Re: Revised 410 Kingsland Avenue Monitoring Well Network Modification Request
ExxonMobil Greenpoint Petroleum Remediation Project
Greenpoint, Brooklyn, New York

Roux Environmental Engineering and Geology, D.P.C. ("Roux"), on behalf of ExxonMobil Oil Corporation (ExxonMobil), has prepared this letter report (Report) to request New York State Department of Environmental Conservation (NYSDEC) approval of monitoring network modifications within the 410 Kingsland Avenue (410 Kingsland) property associated with the ExxonMobil Greenpoint Petroleum Remediation Project (EMGPRP).

ROUX	Compiled by: J.C.	Date: 11/21/25	FIGURE 4
	Prepared by: M.S.R.	Scale: AS SHOWN	
	Project Mgr: C.L.	Project: 0172.0030Y113	
	File: 0172.0030Y5268.4.mxd

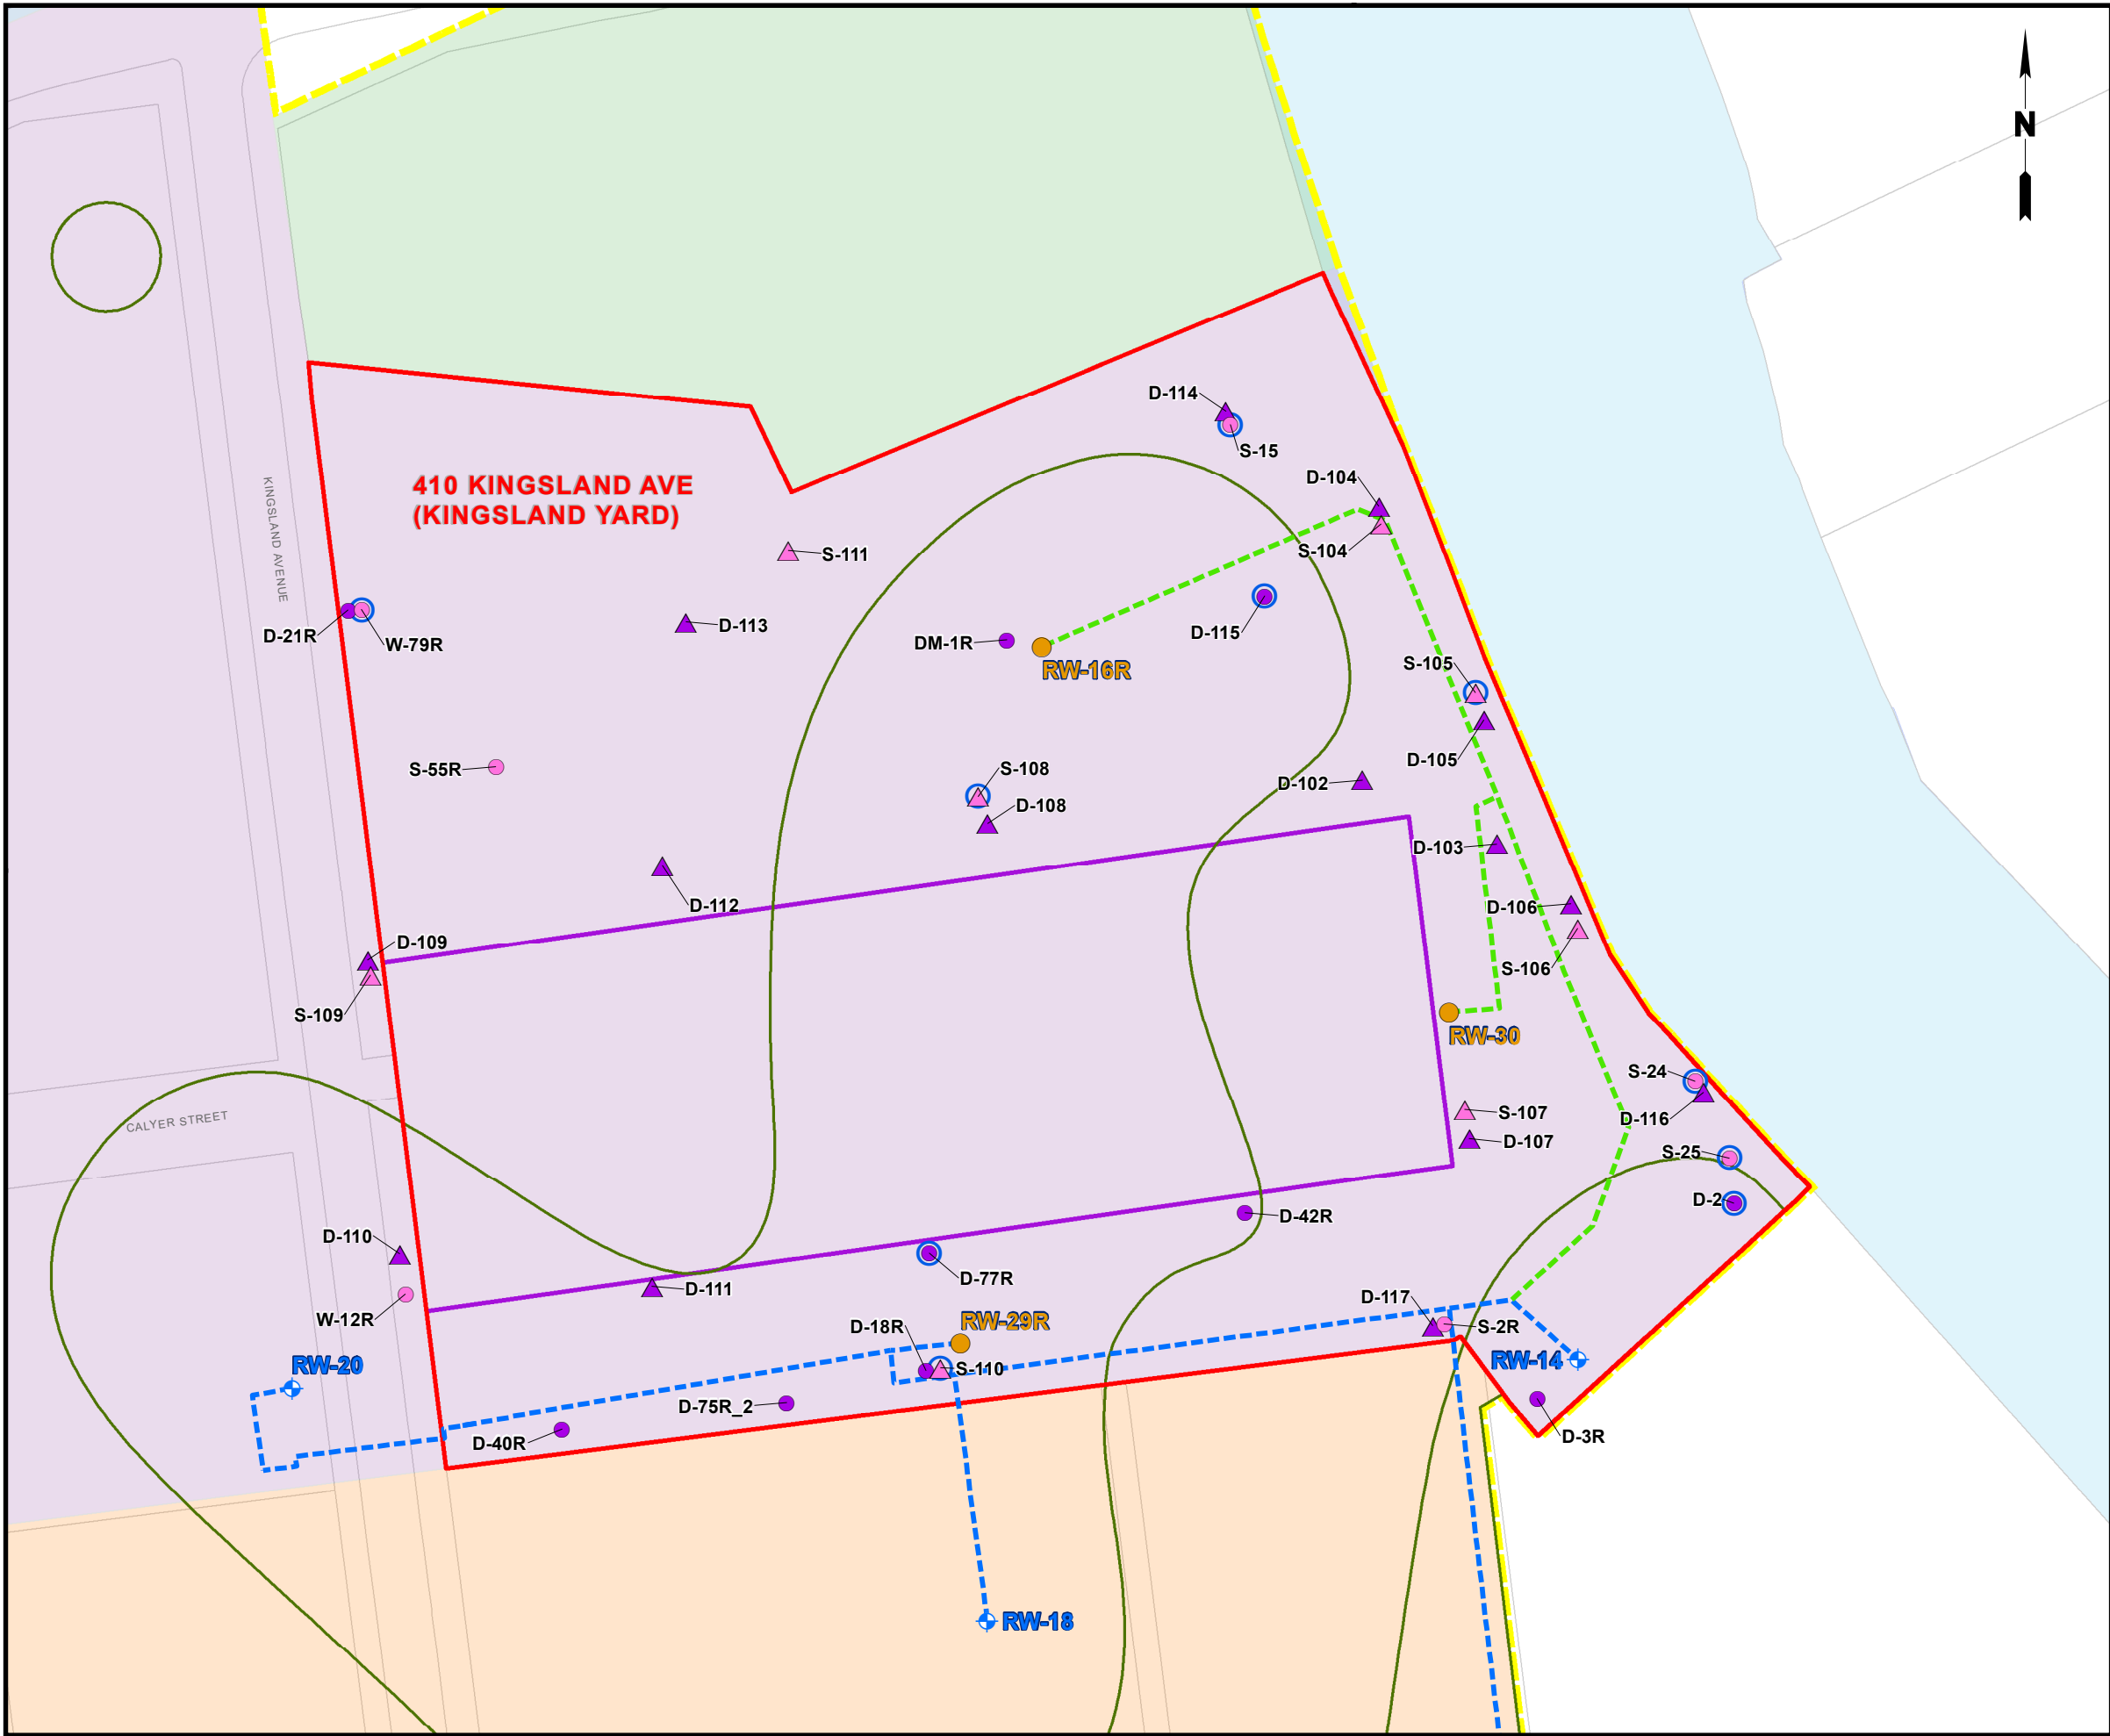
Phase	Phase Implementation Timeline	Scope of Work
Phase 1	Pre-redevelopment activities	<ul style="list-style-type: none"> Installation of nine new monitoring wells along Newtown Creek to monitor for potential migration of product, if any: S-104, S-105, S-106, D-103, D-104, D-105, D-106, D-114, and D-116 (Figure 2). Maintenance of existing monitoring wells until Phase 2.
Phase 2	Redevelopment activities	<ul style="list-style-type: none"> Decommission all existing monitoring wells with the exception of those shown on Figure 3. Maintenance of Phase 2 portion of 410 Kingsland monitoring well network (Figure 3) for the duration of redevelopment activities. Monitoring wells included in Phase 2 of the network will be reinstalled, as needed, if impacted by redevelopment activities.
Phase 3	Post-redevelopment activities	<ul style="list-style-type: none"> Installation of all remaining monitoring wells to achieve the final phase (Phase 3) of the proposed 410 Kingsland monitoring well network (Figure 4).

In addition to the monitoring well network modifications proposed above, recovery wells RW-16 and RW-29 (Figures 1 and 2) are anticipated to be relocated to locations RW-16R and RW-29R, as depicted on Figures 3 and 4. The recovery well relocation activities will be performed in accordance with the Recovery Well RW-16 and RW-29 Relocation Request letter dated September 18, 2023 and the related response to comments letter dated April 12, 2024 and approved by the NYSDEC in a letter dated June 6, 2024. Further clarifications regarding an alternative location for RW-16R were provided to the NYSDEC in an email correspondence dated November 18, 2025 which was approved by the NYSDEC in an email dated November 20, 2025 (Attachment 1).

- NOTES**
1. THE ANTICIPATED RELOCATION OF RW-16, RW-29, AND THE ASSOCIATED GROUNDWATER REMEDIATION SYSTEM PIPING WAS APPROVED BY THE NEW YORK STATE DEPARTMENT OF ENVIRONMENTAL CONSERVATION IN THE RECOVERY WELL RW-16 AND RW-29 RELOCATION REQUEST APPROVAL LETTER DATED JUNE 6, 2024. RW-30 IS INCLUDED AS A CONTINGENCY FOR FUTURE INSTALL, IF DETERMINED NECESSARY FOR HYDRAULIC CONTROL.

2. MONITORING WELLS WITH A NAME ENDING IN "R" ARE CONSIDERED REPLACEMENT WELLS FOR A PREVIOUSLY EXISTING MONITORING WELL. REPLACEMENT MONITORING WELLS WILL BE NAMED UTILIZING THE PREVIOUSLY EXISTING WELL NAME WITH AN "R" AT THE END (I.E., D-3R IS THE REPLACEMENT MONITORING WELL FOR D-3).

3. IF ANY EXISTING MONITORING WELLS ASSOCIATED WITH PHASE 2 OF THE 410 KINGSLAND MONITORING WELL NETWORK ARE DESTROYED DURING THIRD-PARTY REDEVELOPMENT ACTIVITIES, THEY WILL BE REINSTALLED IN A COMPARABLE LOCATION AND NAMED UTILIZING THE REPLACEMENT WELL NAMING STRUCTURE (I.E., D-2 WOULD BE REINSTALLED AS D-2R)
